ISSUE: Permit to Demolish/Capsulate (partial), Certificate of Appropriateness for alterations, and Waiver of Fence Height

APPLICANT: Barbara and George Barlow

LOCATION: Old and Historic Alexandria District
808 Duke Street

BOARD ACTION 9/1/2021: Approved, as Submitted

Selective Demolition

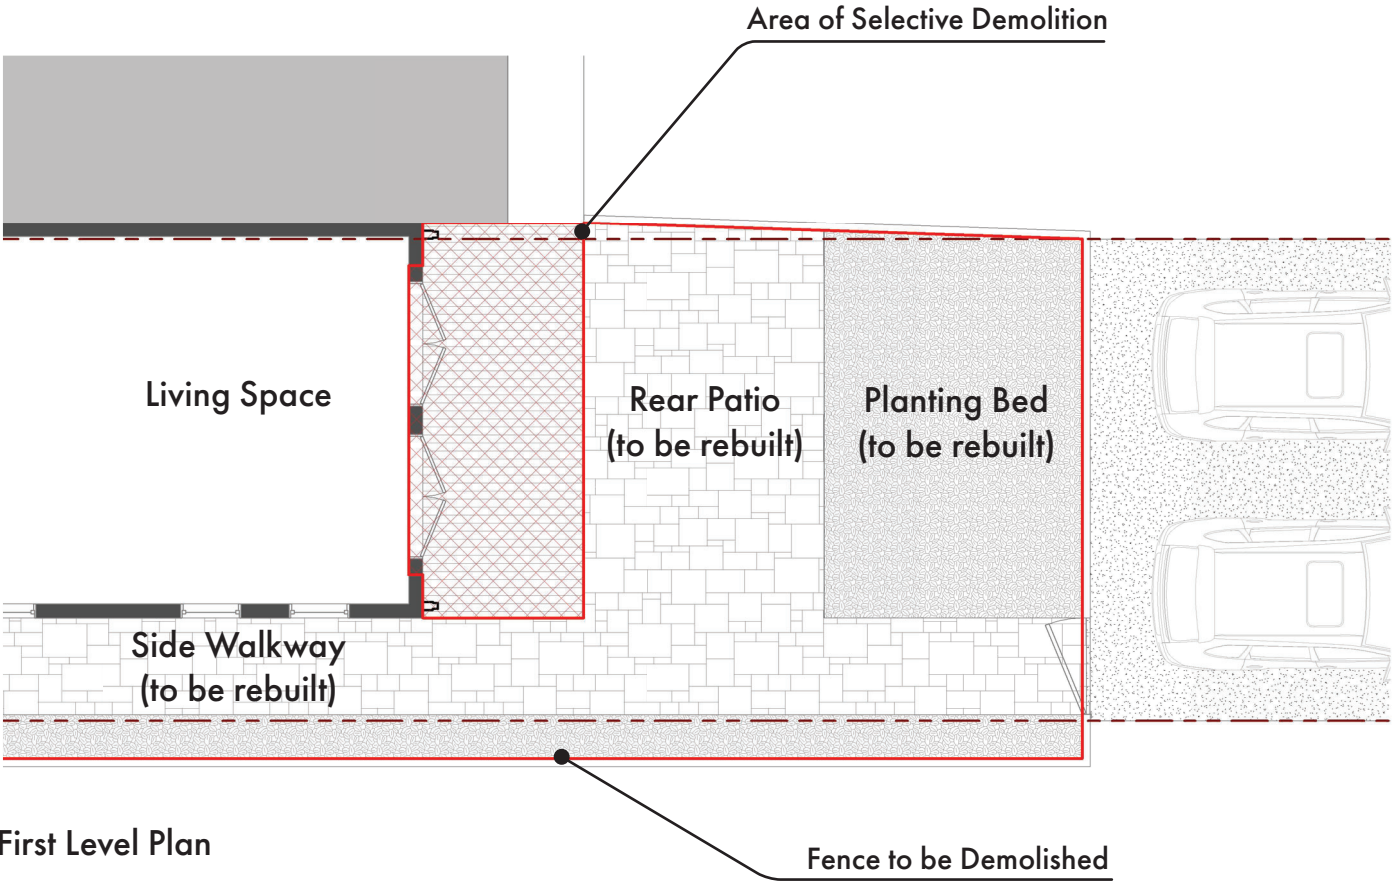
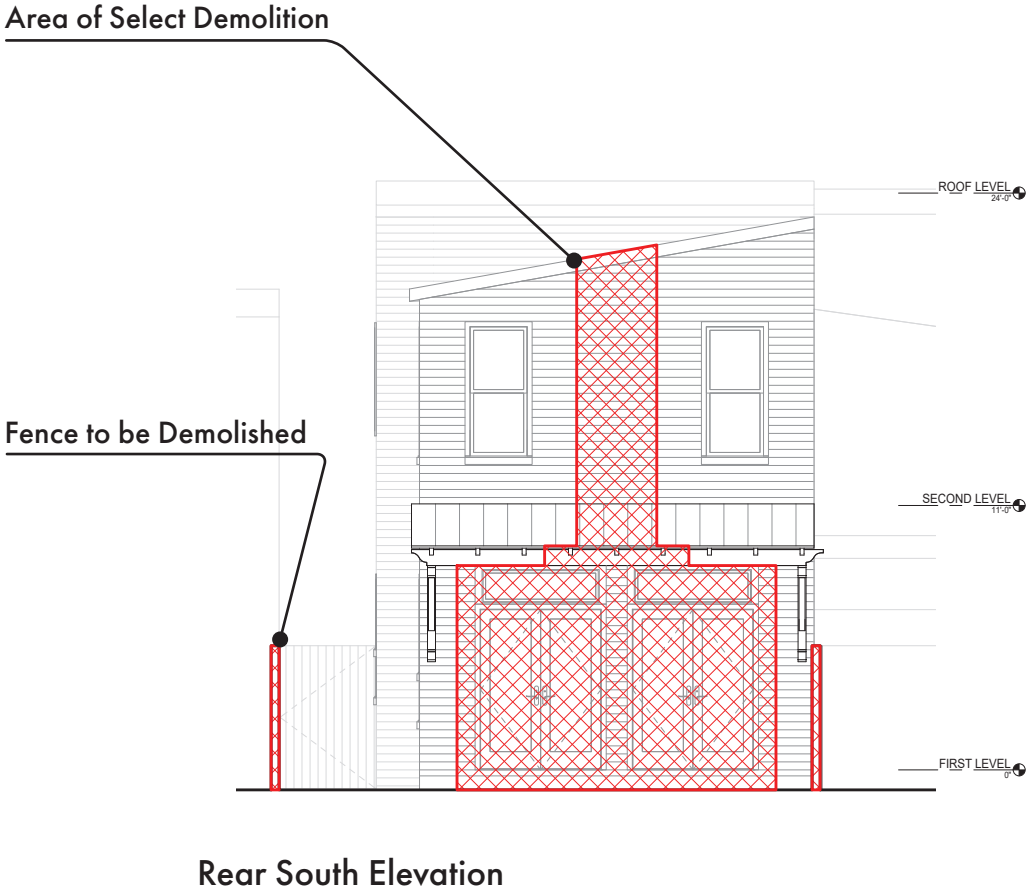
In the opinion of staff, none of the criteria for demolition and capsulation are met and the Permit to Demolish/Capsulate should be granted. The amount of wall area to be demolished/encapsulated (170sq.ft.) is limited to the rear elevation and will not significantly affect the architectural integrity of the building. Permit #23399, issued in 1966, approves replacing the bricktex siding with aluminum siding, therefore indicating that the material to be encapsulated is not original. Additionally, the alterations on the 1st-story will be minimally visible because of the rear fence. Portions of the chimney will be visible from the public alley.

Proposed Rear South Elevation

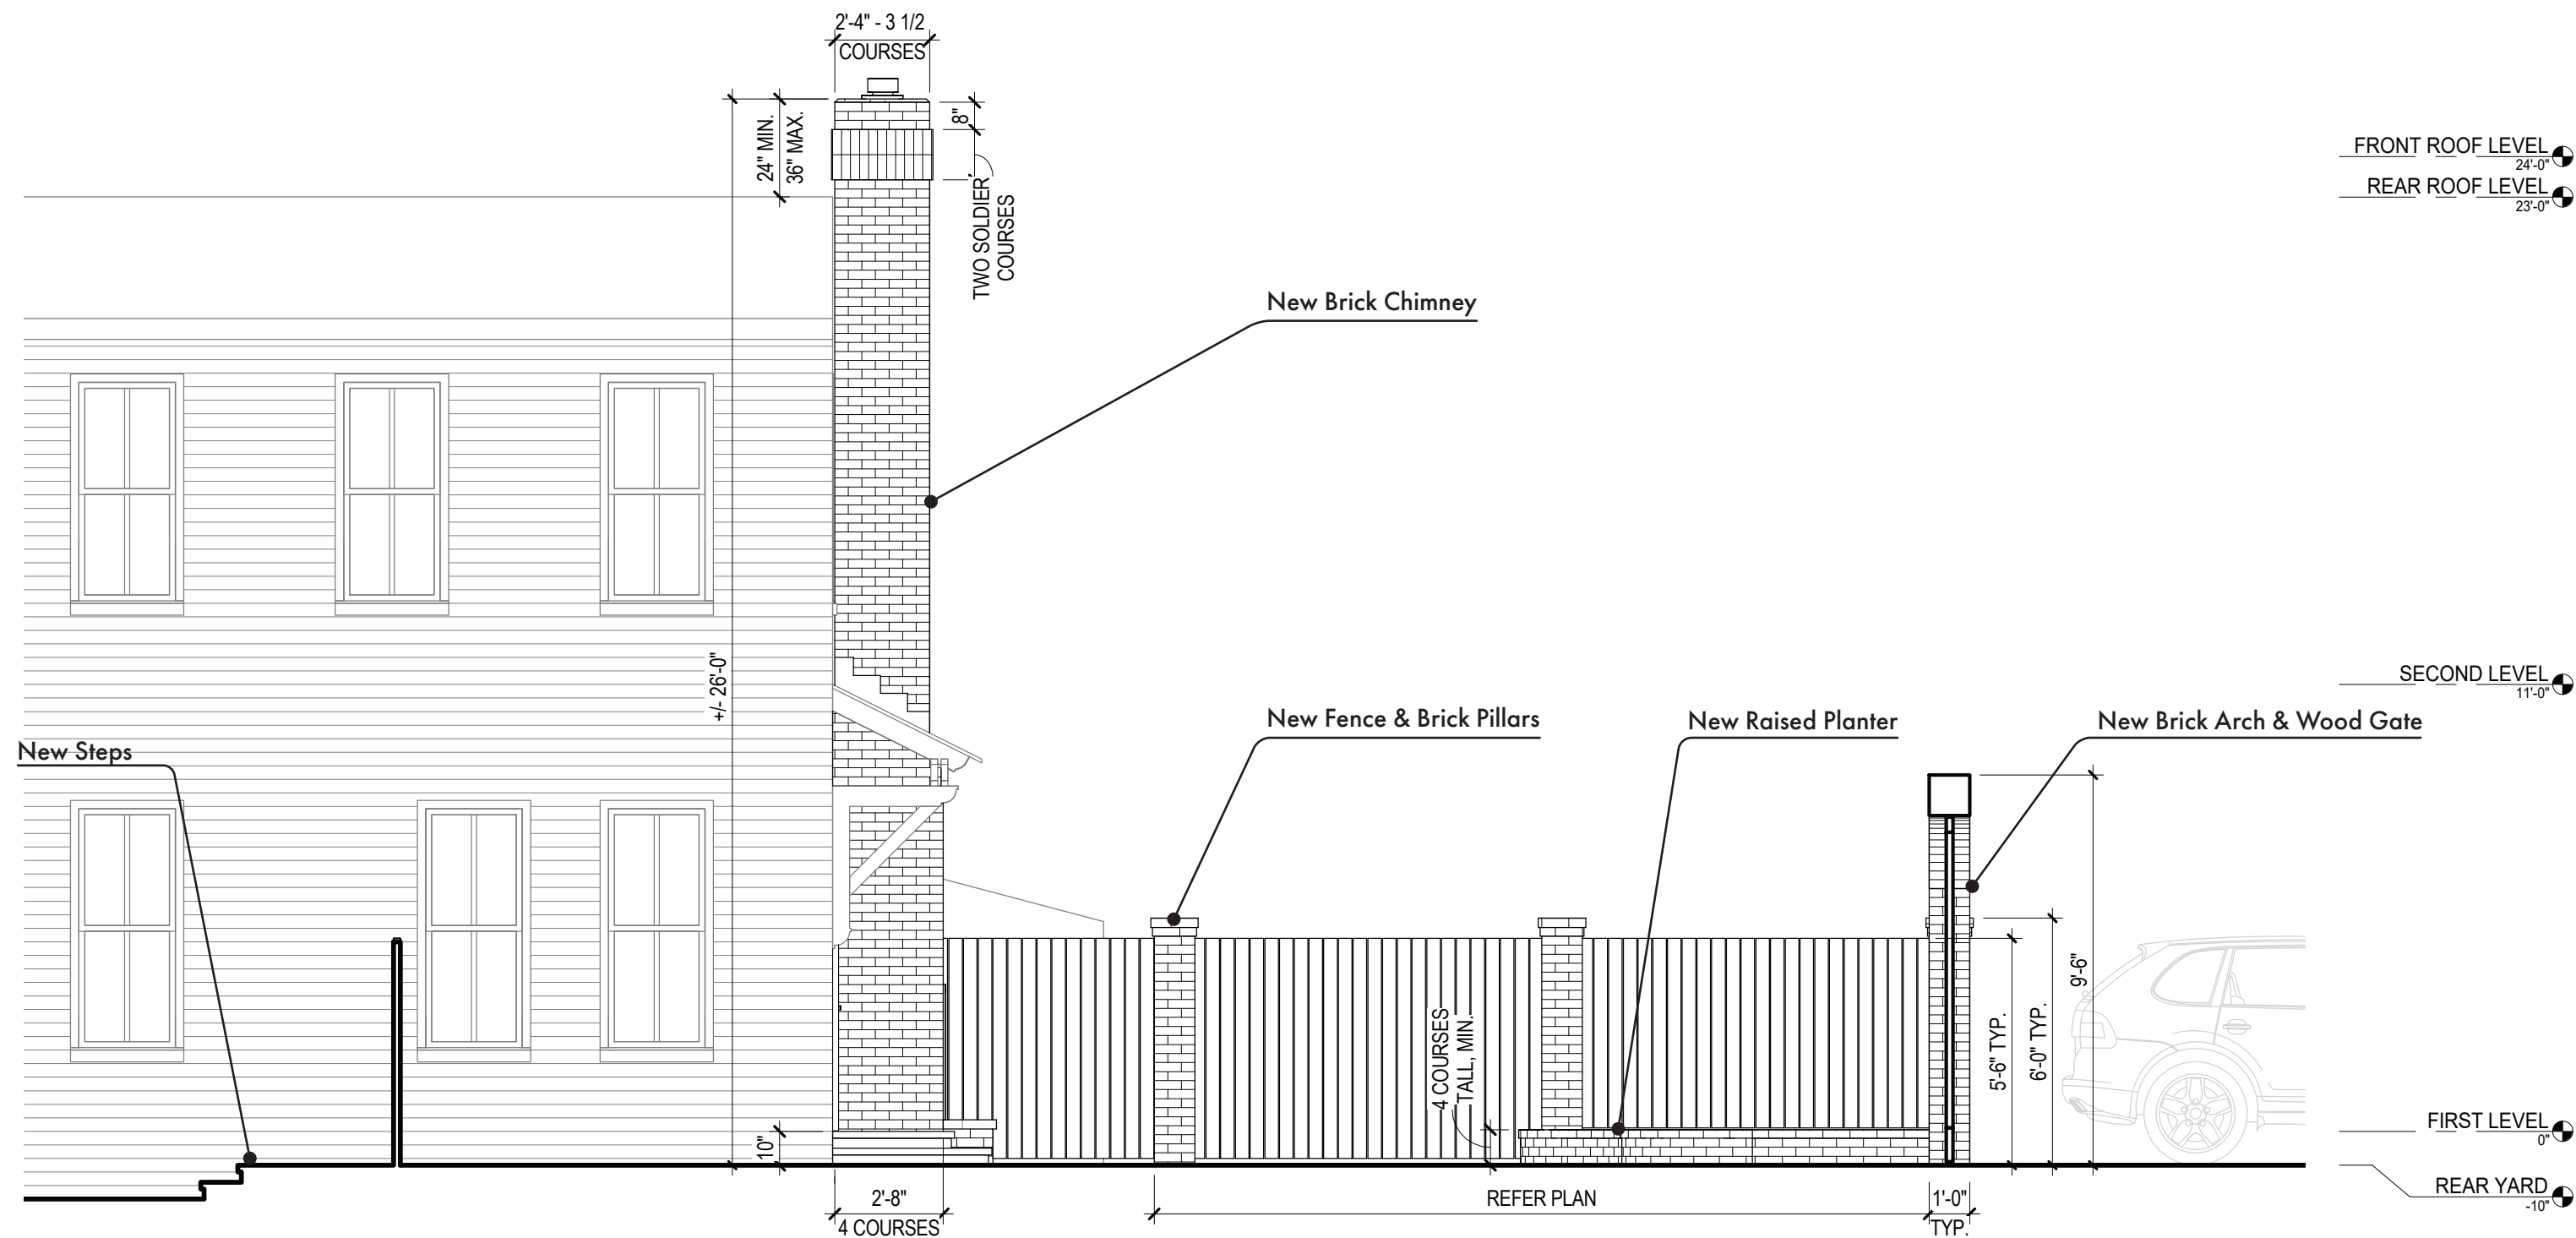
Yvonne Callahan, 735 South Lee Street, thinks chimney should be smaller.

Mr. Adams liked the fence with brick piers. He suggested that the fireplace be on the side and smaller.

Ms. Irwin supported the fence with brick piers and a smaller chimney.

Mr. Spencer prefers a narrower chimney and doesn't like the existing shed roof.

The *Design Guidelines* state that chimneys are functional elements of a building and provide visual variety to the roofline. A chimney can also have an important impact on the overall visual composition of the building. The proposed outdoor fireplace and chimney are architecturally appropriate and do not cause a visual disruption of the unified building design.

Proposed West Elevation

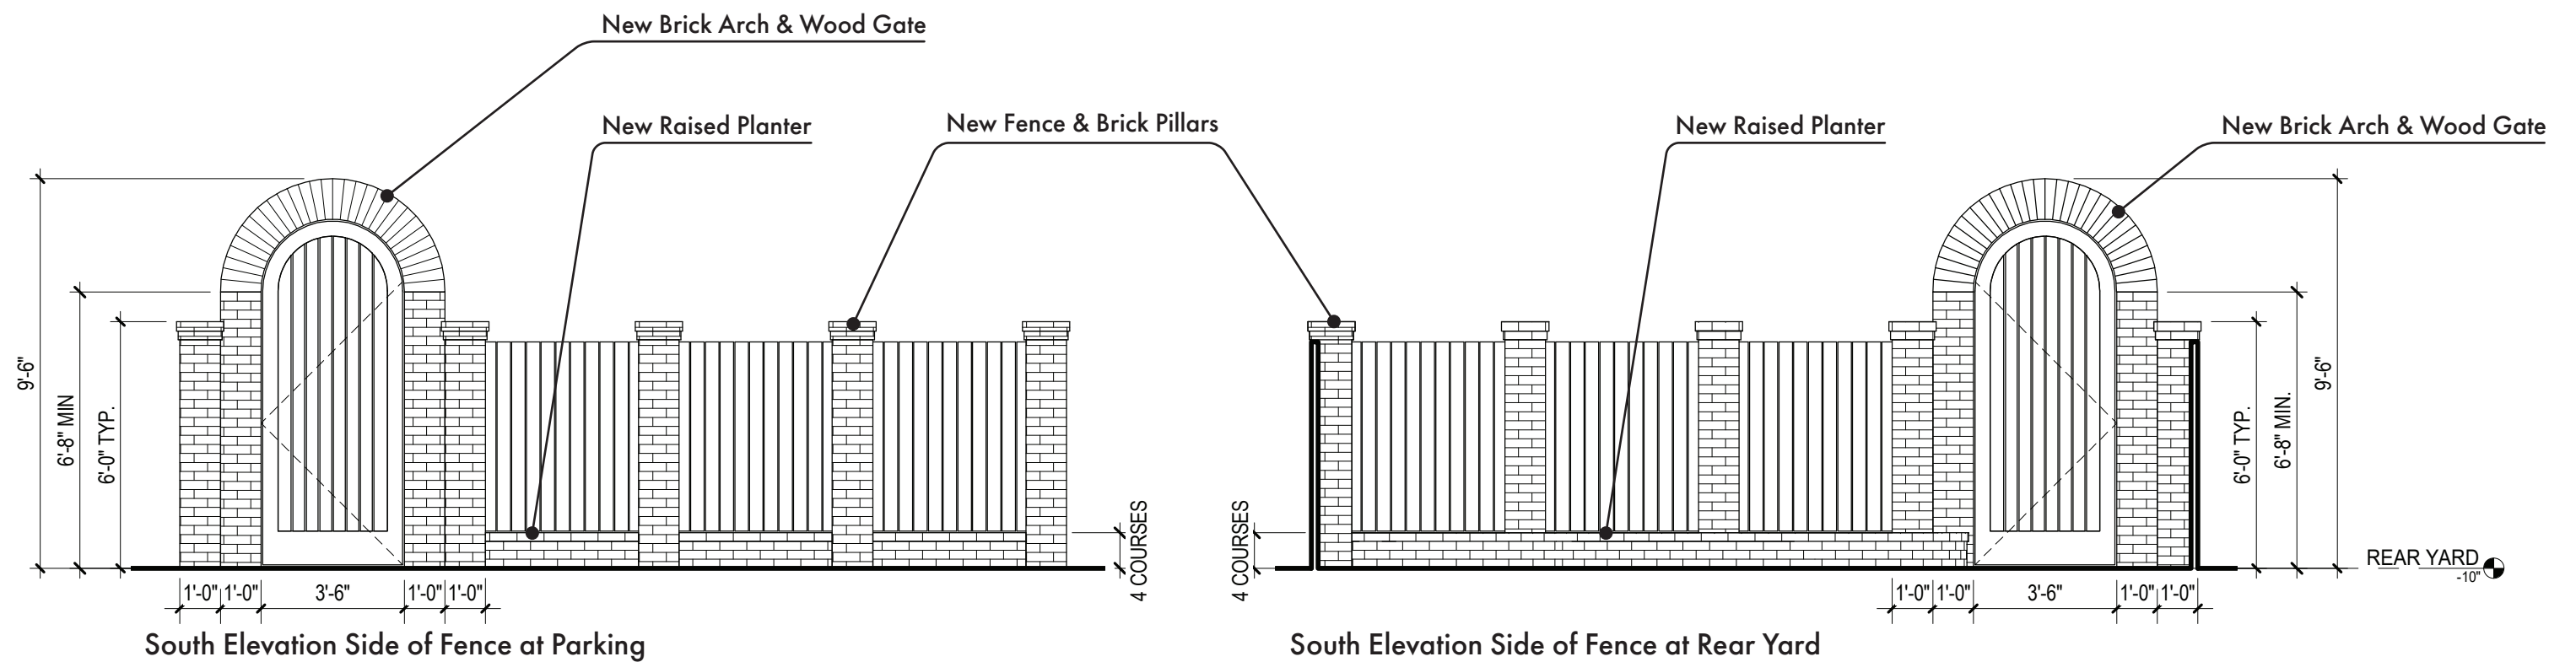
Staff has no objection to the proposed alterations, which are minimally visible and will have little effect on the historic fabric of the property. Staff also supports the waiver of fence height, as it is

limited to the proposed brick arch surrounding the gate. The proposed brick arch for the wood gate will be 5'-6" wide and 9'-6" in height. The remainder of the wood fence with brick pillars will not exceed 6'-0" in height.

F-2 The proposed trellis gate does not fall within any required yard and therefore it's height of 9.5 feet is allowed.
